IREDELL COUNTY HEALTH DEPARTMENT

IMPROVEMENT PERMIT / AUTHORIZATION TO CONSTRUCT / OPERATION PERMIT / EXISTING SYSTEM INSPECTION

PERMIT# 100657 PIN# 4741-27-1036 DATE 1-24-05

SUBDIVISION Martha Lowe Land BLOCK / SECTION LOT 25 LOT AREA 1.845 ac SITE CLASS PS DESIGN FLOW 480 L.T.A.R. .25

INITIAL SITE SKETCH

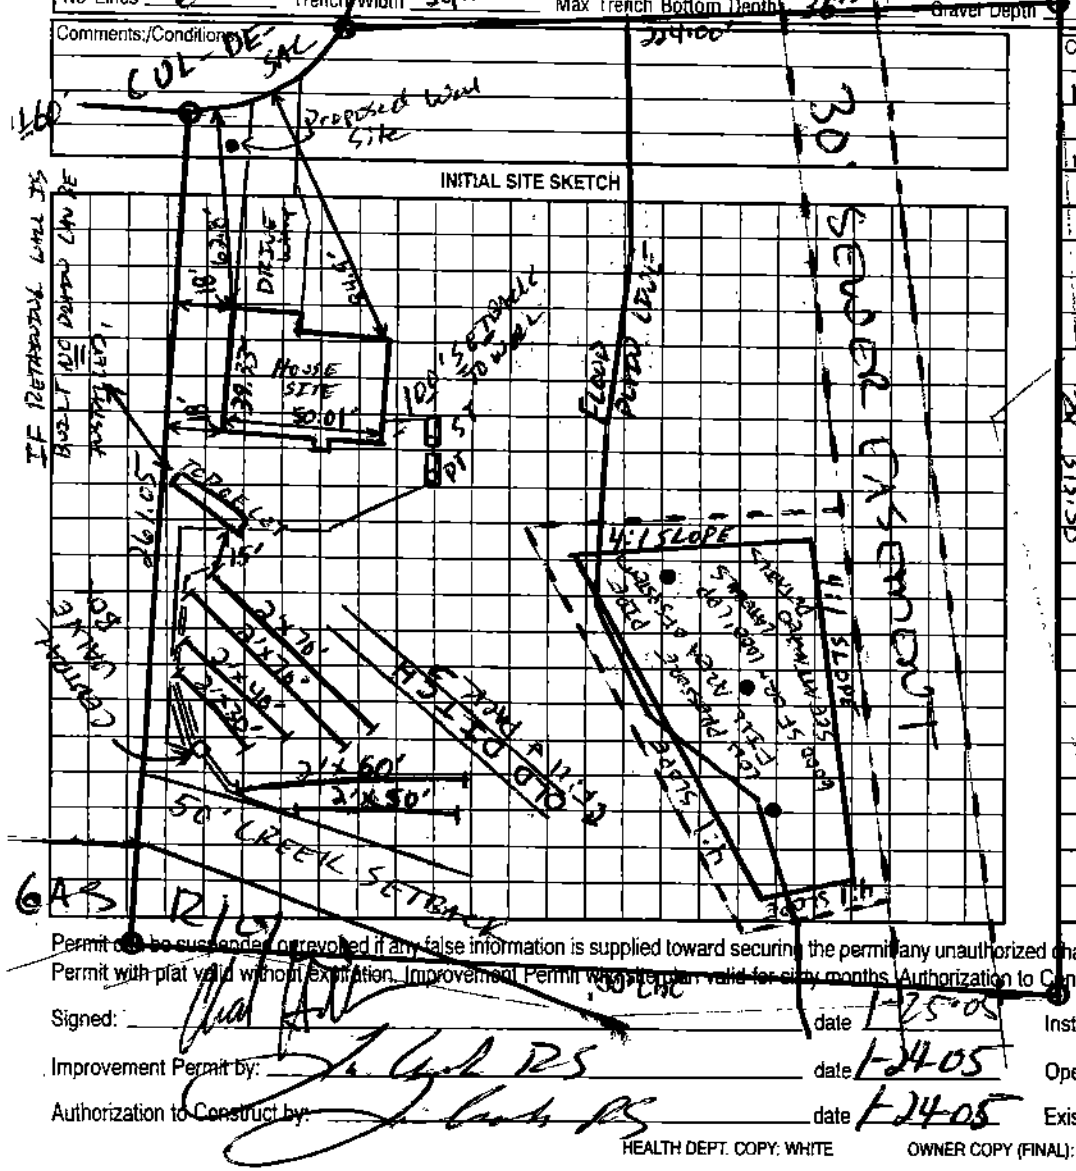
Comments/Conditions: (1) TANKS HAVE TO BE PRESSURE TESTED (2) DITCH HAS TO BE FILLED & PACKED (3) System is FLAGGED (4) THIS IS A REDRAW. ONLY CHANGES MADE WAS FRONT P/L WAS CHANGED DUE TO THE CUL-DE-SAC MOVING UP & SYSTEM WENT FROM AS BUILT SKETCH 3 BEDROOM TO A 4 BEDROOM

ST=1112 gal PT=492¼ gal = 1120 LINEAR INCHES, MARVOO OW INSIDE OF TUFF TITE FILTER & MARVOO, W'D 60' & 50' LINES, AND ¼" TALL PORT/FOOT, ALLOWABLE BY RULES, LC 1-26-05

LC PRESSURE FAILED, TANKS NEED TO BE O/C NEEDS PRESSURE & CONTRACT & DITCH FILLED

SET PRESSURE, NEEDS CONTRACT & DITCH FILLED TO MAINTAIN SETBACKS OFF ROADS

1-27-05 W'D LINES SATISFACTORY. W'D FOR FINAL

GOT CONTRACT 1-28-05 LC

W'D DITCH & CONTRACT RECEIVED OK LC 1-28-05
